**1703 N. RIVER HILLS ROAD**  
**MARINA RECONSTRUCTION**

**1703 RIVER HILLS RD, 78733**  
**SP-2022-0167D**

## VARIANCE REQUESTS

**FUEL LINE LAYOUT**

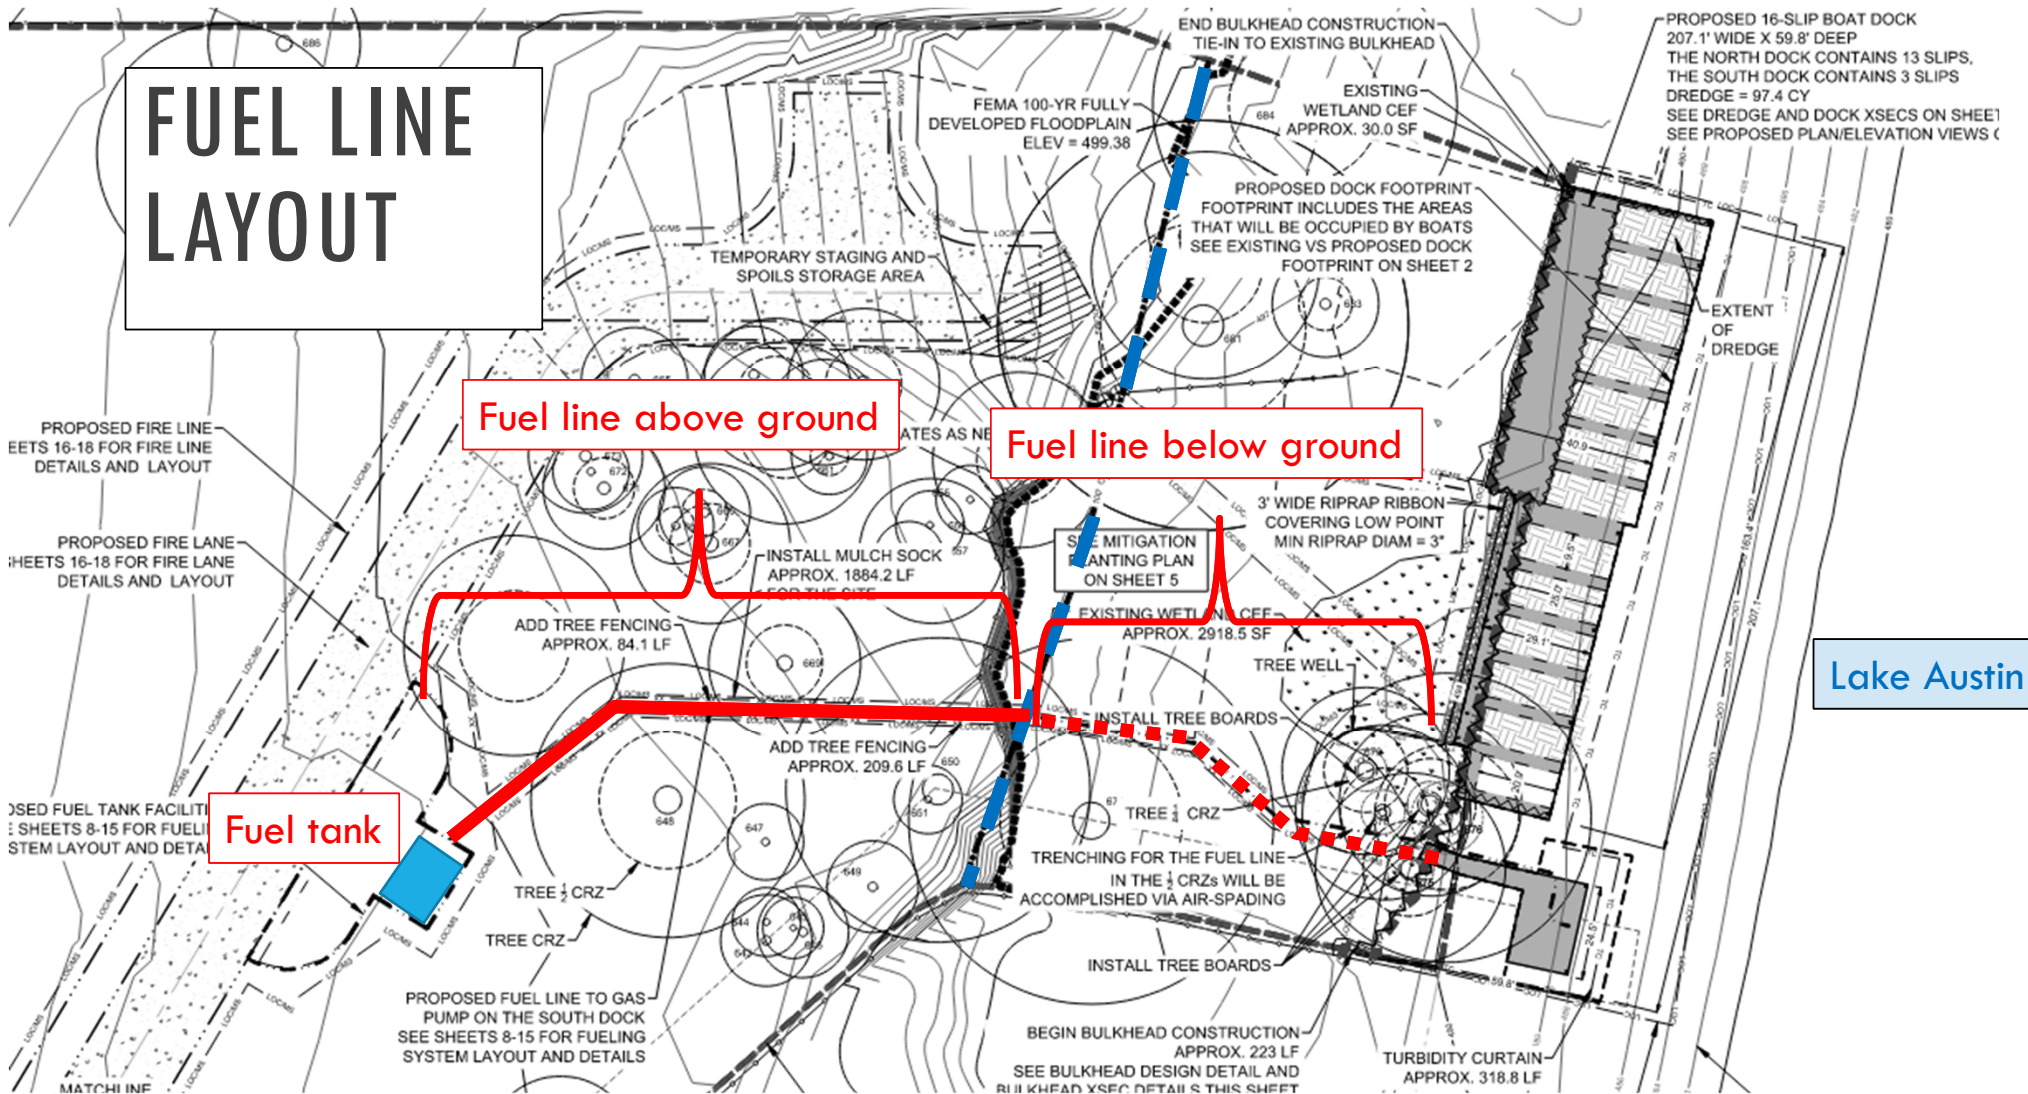
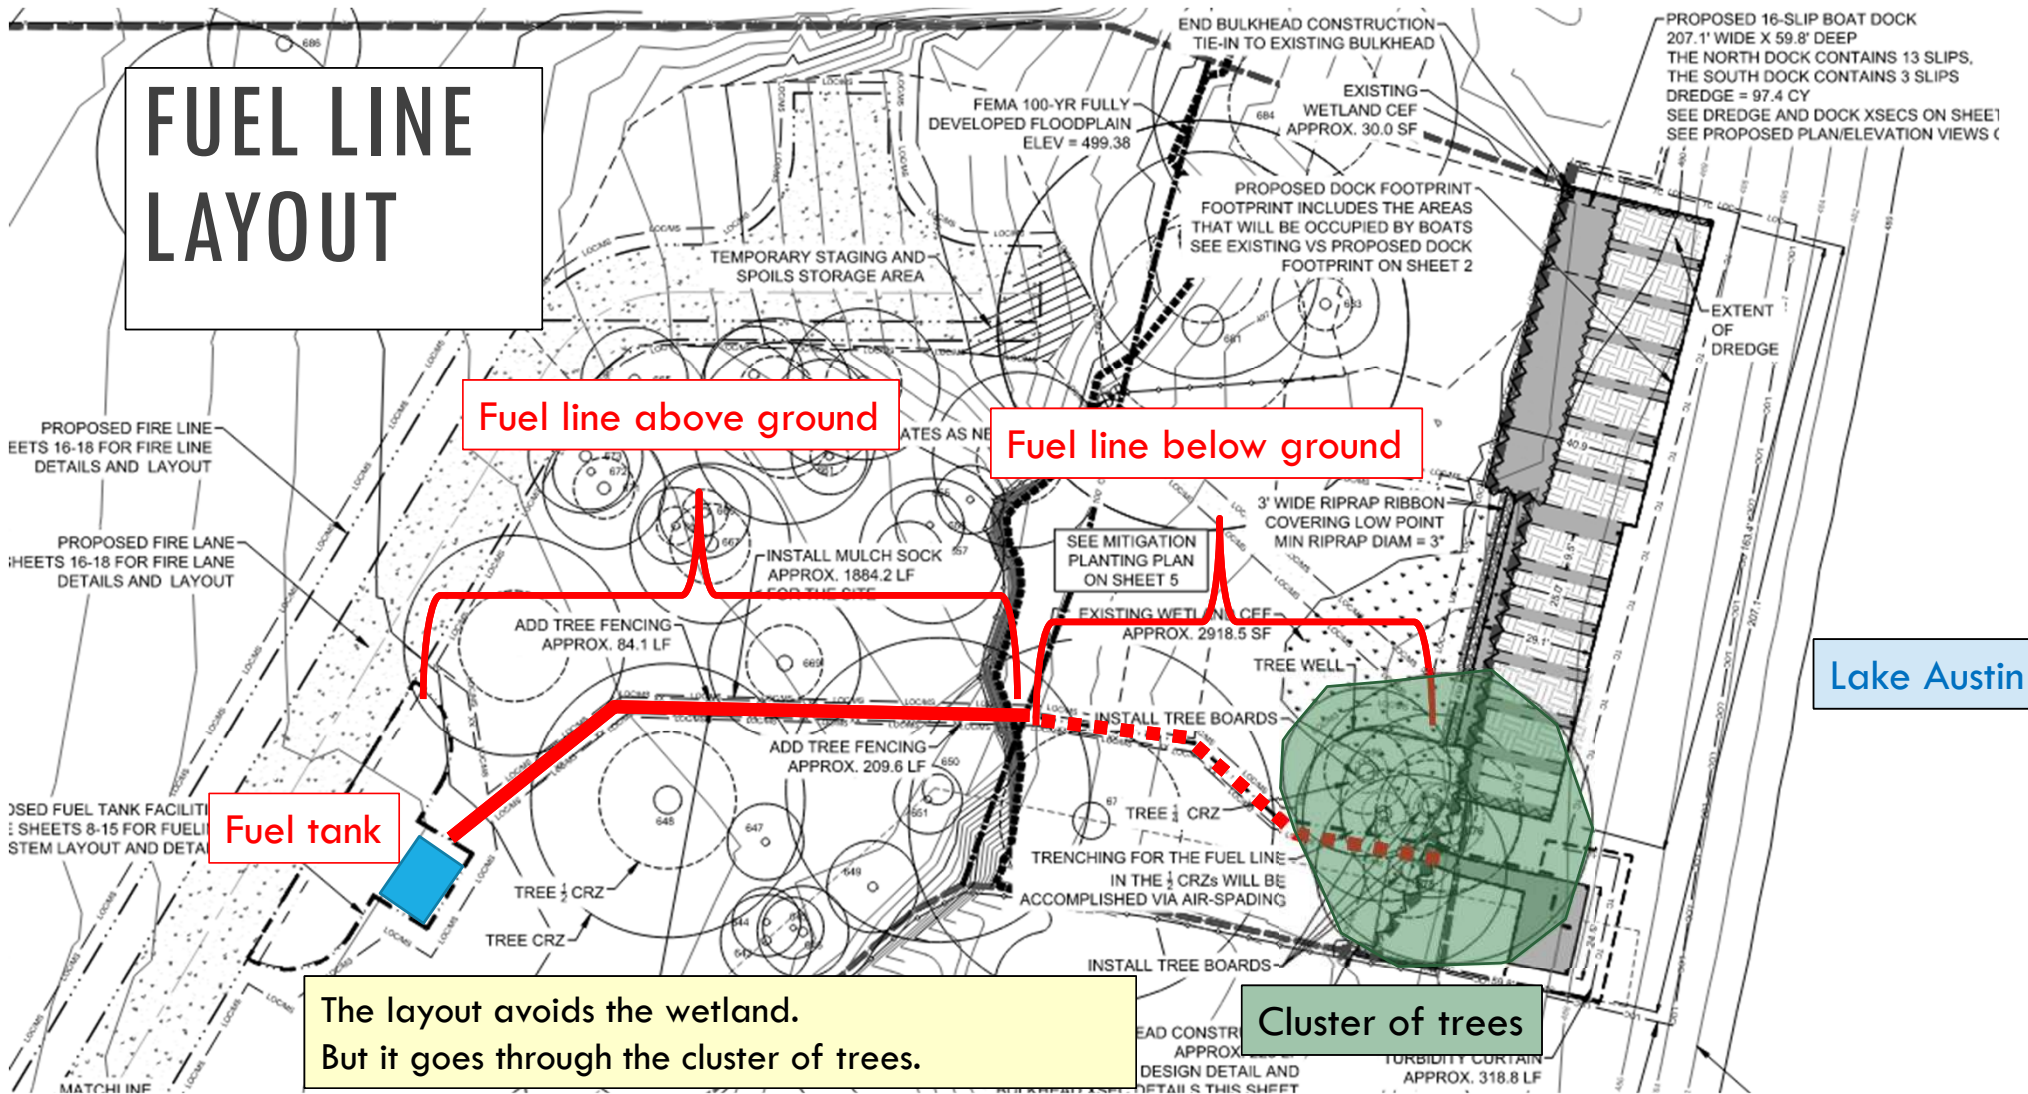
Request to vary LDC 25-8-261 CRITICAL WATER QUALITY ZONE DEVELOPMENT to allow, in the CWQZ of Lake Austin, development of a gasoline fuel line with a dispenser at the dock for re-fueling private boats.

The layout avoids the wetland.

Staff determines that the findings of fact have *not* been met:

- Variances have not been granted for projects with similar code requirements, the most recently approved fueling operation on Lake Austin having been approved in 1985.
- The variance
  - Is necessitated by the applicant's design choice and does not provide greater overall environmental protection;
  - Is not the minimum deviation necessary to allow a reasonable use of the property, as the marina and business allow reasonable use; and
  - Creates a significant probability of harmful environmental consequences.
- Water quality will not be equal to or better than water quality without the variance.

# VARIANCE REQUEST 2

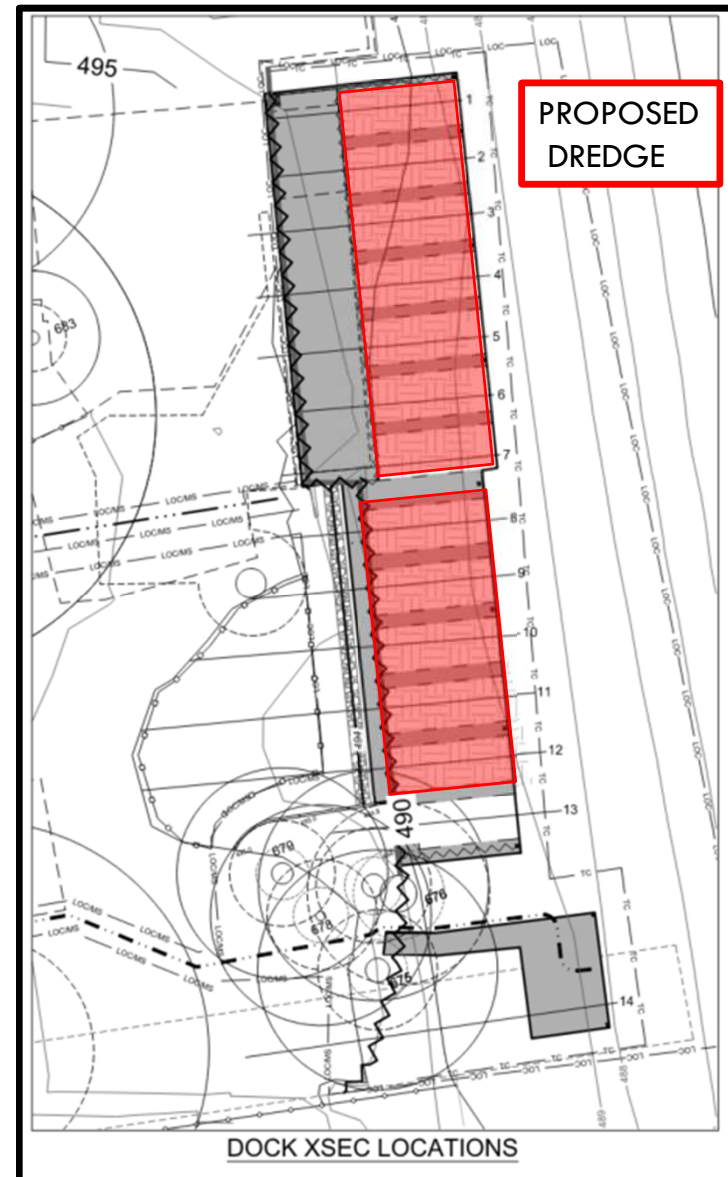
- Existing marina built prior to 1965
- Replace/Rehabilitate
  - Existing 21 slips
  - Proposed 16 code-compliant slips
  - Within the existing footprint

- LDC 25-8-368 (E) allows 25 CY dredge per site plan
- Proposing 6.1 CY per slip, total of 97.4 CY
- If 25 CY per slip, would be total of 400 CY
- **Per slip: 6.1 CY < 25 CY**
- **Total: 97.4 CY < 400 CY**

## Enhancements:

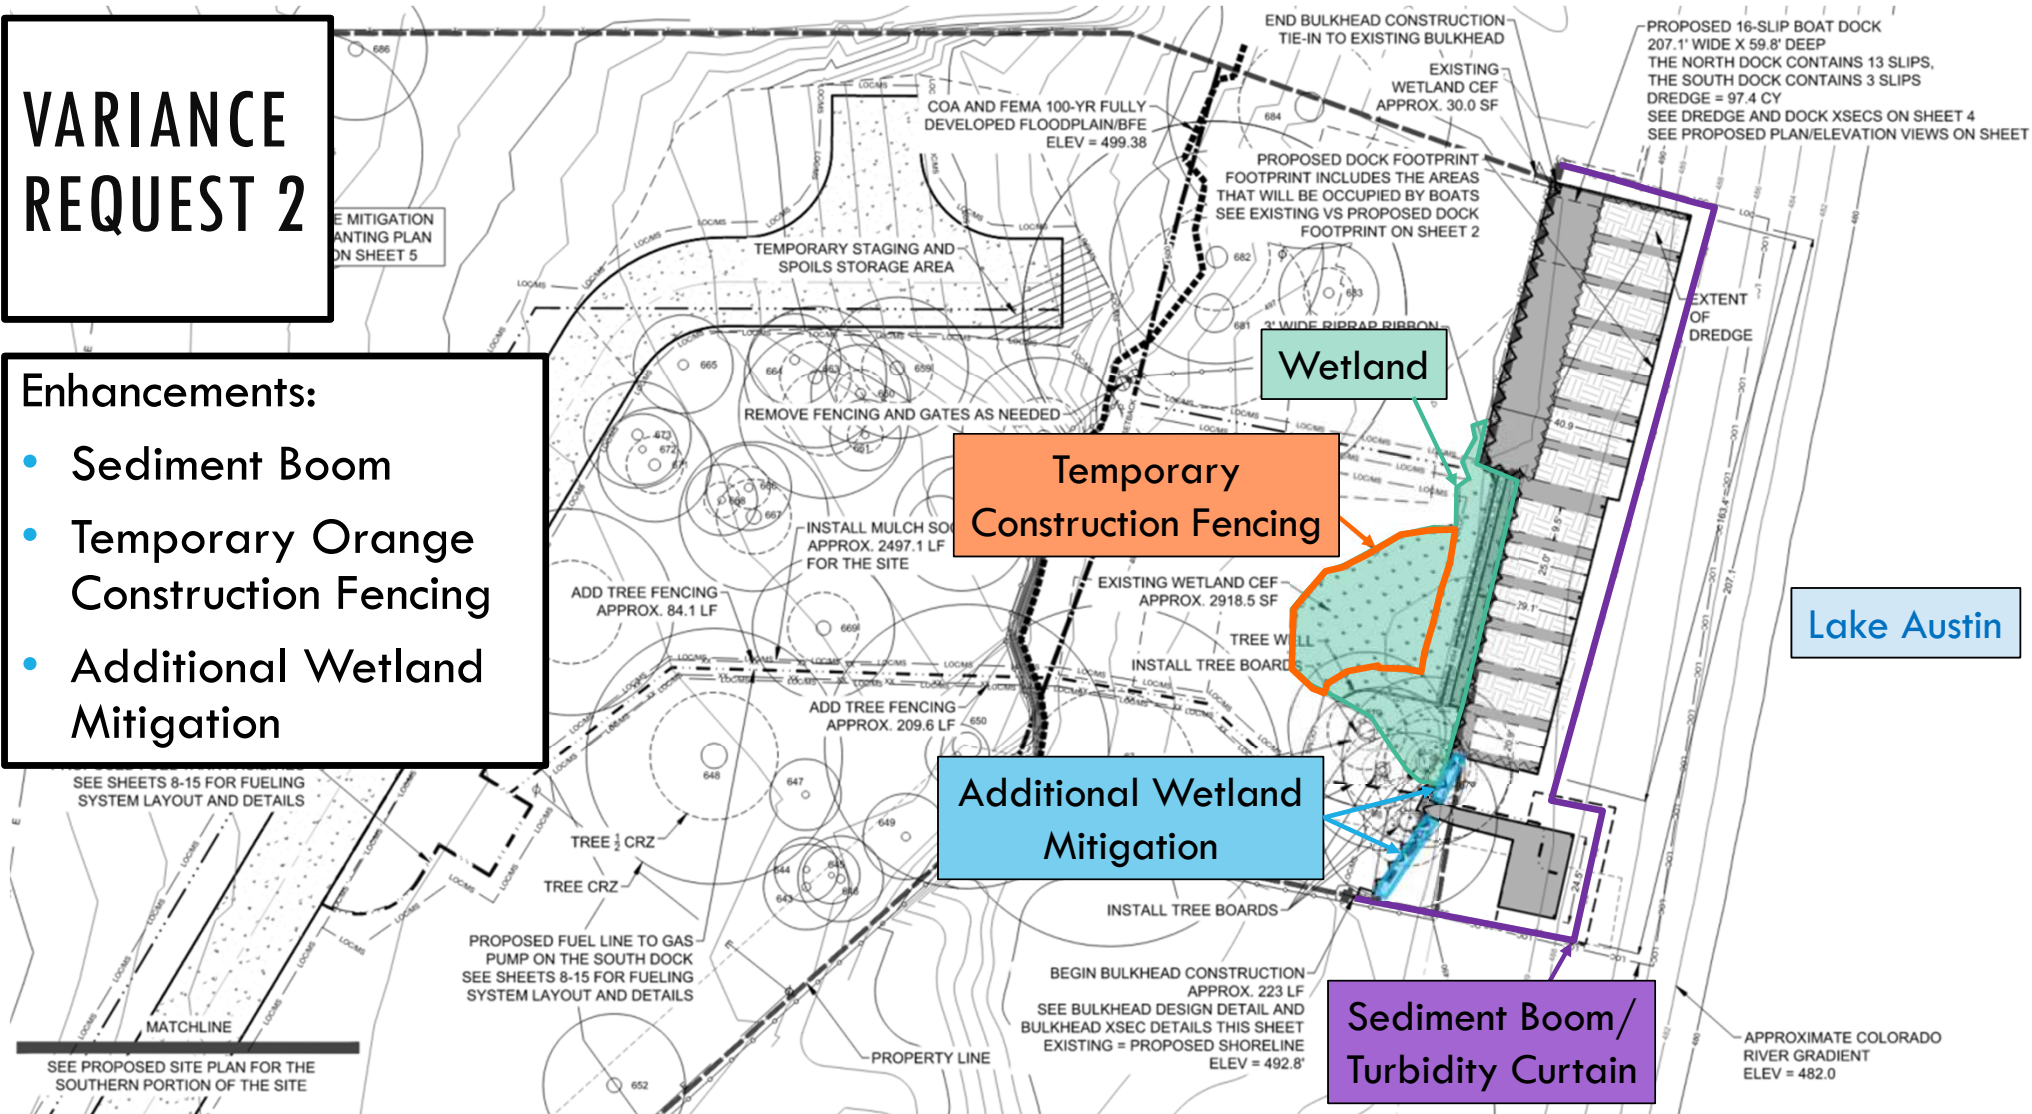
- Sediment Boom
- Temporary Orange Construction Fencing
- Additional Wetland Mitigation

Staff determines that the findings of fact have been met:

- Similar variances have been granted for projects with similar code requirements.
- The variance
  - Is necessitated by topographic features, not design choice;
  - Is the minimum deviation from the code; and
  - Is unlikely to result in harmful environmental consequences.
- Water quality will be equal to or better than water quality without the variance.

Staff recommends this variance, with the following conditions:

1. Install sediment boom
2. Install temporary orange construction fencing around wetland CEF
3. Provide additional wetland mitigation
